CITY OF SANTA FE, NEW MEXICO
RESOLUTION NO. 2023-10

ADOPTING A MASTER PLAN FOR TWO TRACTS OF LAND LOCATED AT 3600 AND 3740 SOUTH MEADOWS ROAD, WITHIN THE CITY OF SANTA FE, AND COMPRISING AN AREA OF APPROXIMATELY 22.2 ACRES. (3600 AND 3740 SOUTH MEADOWS MASTER PLAN, CASE NO. 22-5618)

EXHIBIT C

EXHIBIT A
Technical Corrections
3600 and 3740 South Meadows Master Plan

ONSITE PONDING CALCULATIONS

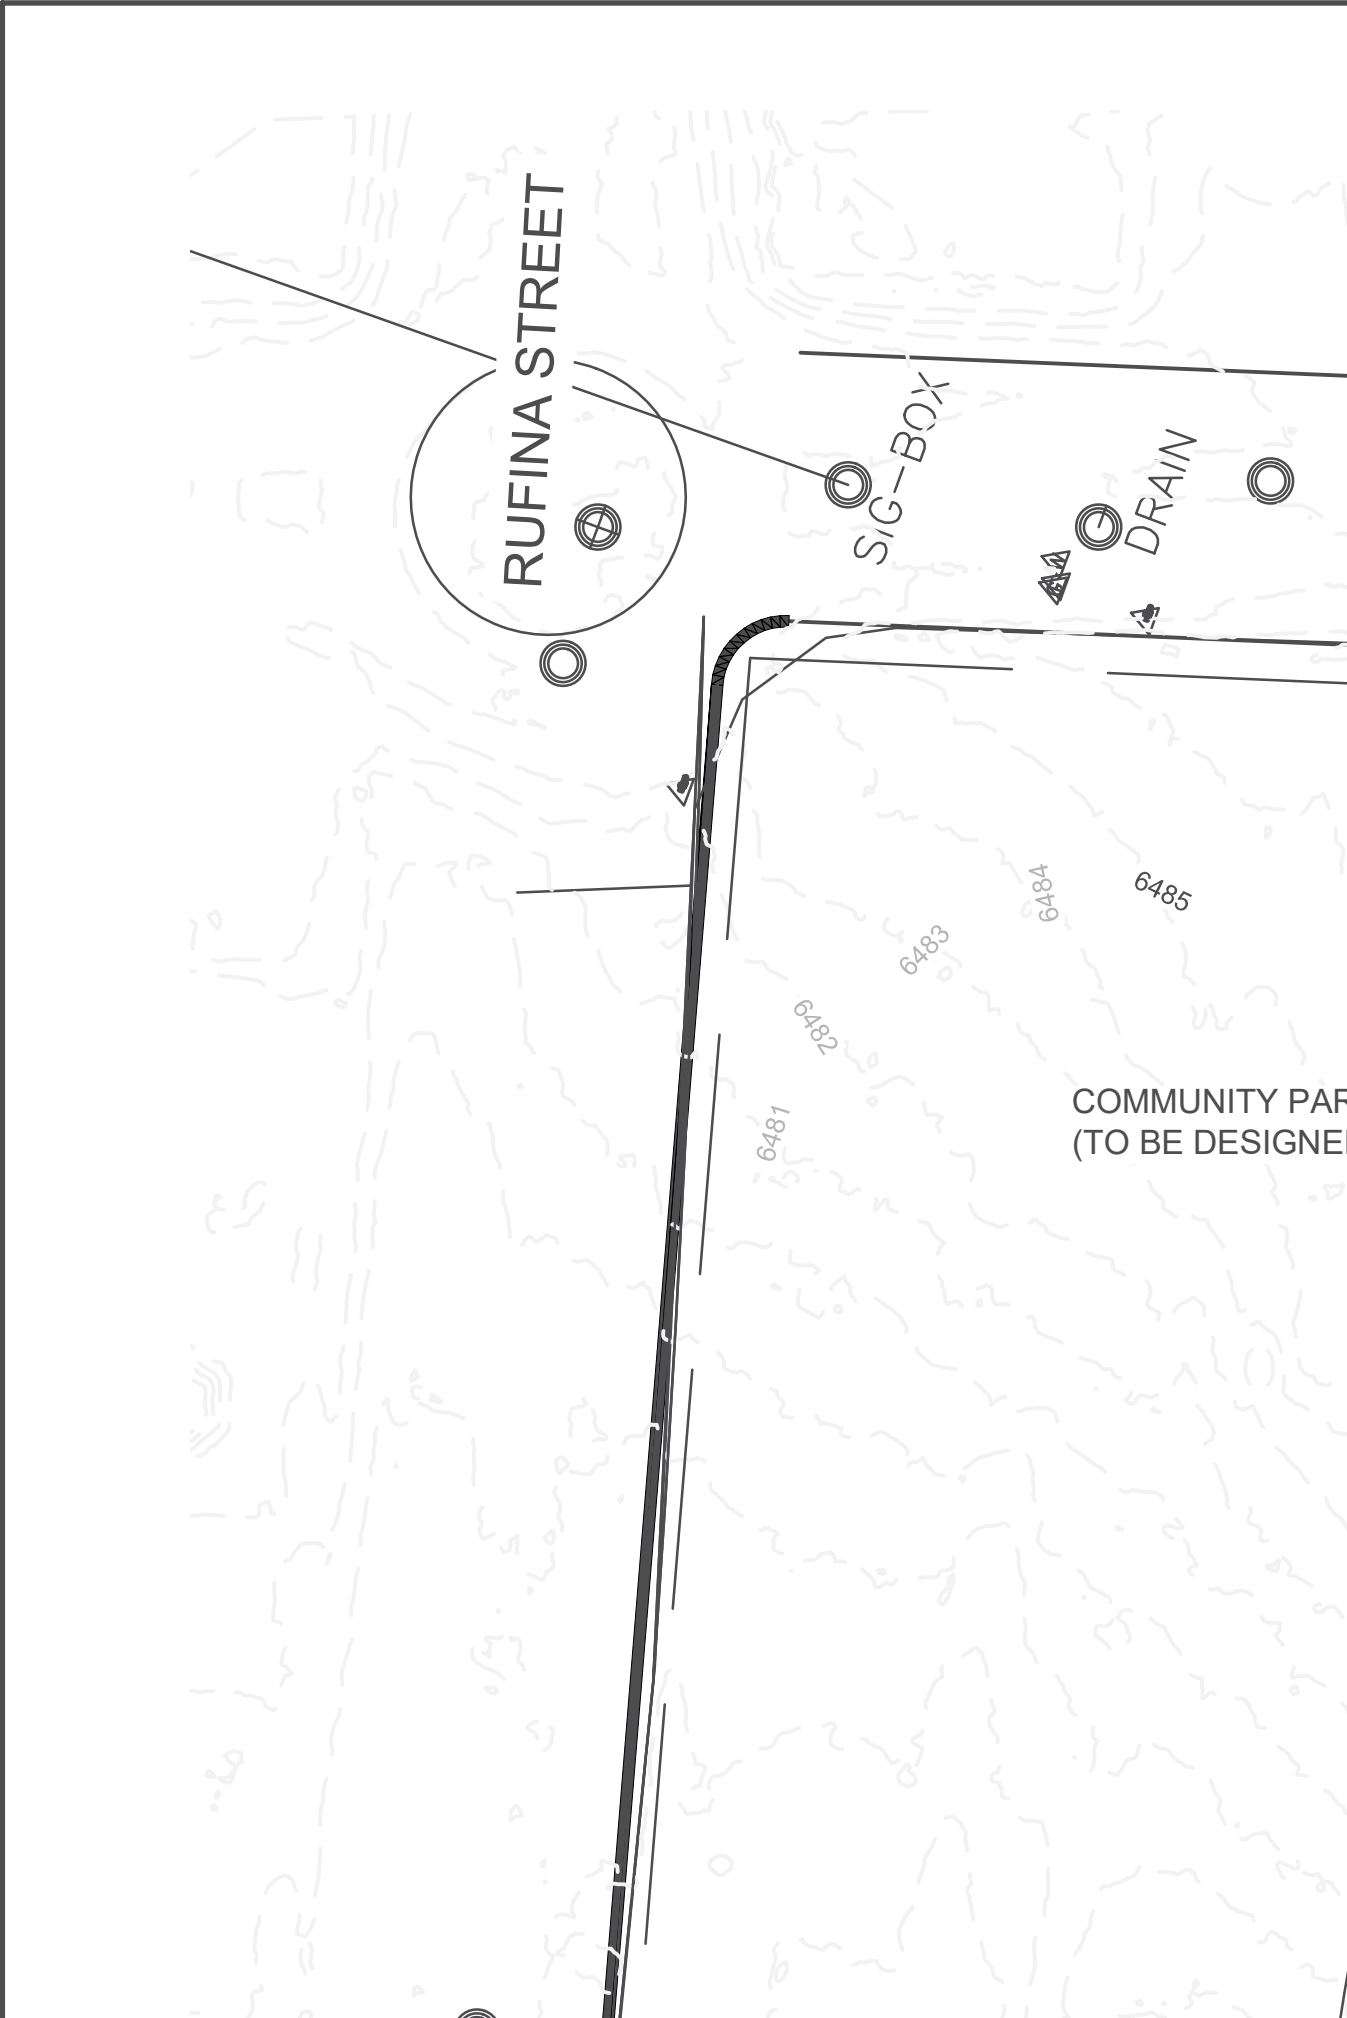
17	The grading plan states that 67,644 Cu Ft of water must be ponded. The calculations do not state	Land Use/Terrain Management	Prior to recording plat

how much impervious surface is assumed on each lot or if a minimum amount of water must be retained on each lot. The pond calculations do not state that roadways are included. No ponding area is shown on the grading plan. Prior to recording plat		
18	The park should be built as part of phase 1. All required ponding for phase one should be complete with phase one.		Shown prior to planning commission for phased project review
19	Road 1 to be changed to partial access (Right-in/Right-out/Left-in) in consideration of the full access points on east side of the roadway (Galleria Grande and Primo Colores).	Traffic Consultant/Wilson & Co	Prior to filing the Development Plan
20	An approved Water Plan will be required. Water Plan to be submitted to the City Water Division for review.	Public Utilities/ Water Division	Prior to Sign Off for Final Development Plan
21	An Agreement to Construct and Dedicate (ACD) from the Water Division will be required for all new public water infrastructure.		Prior to Construction
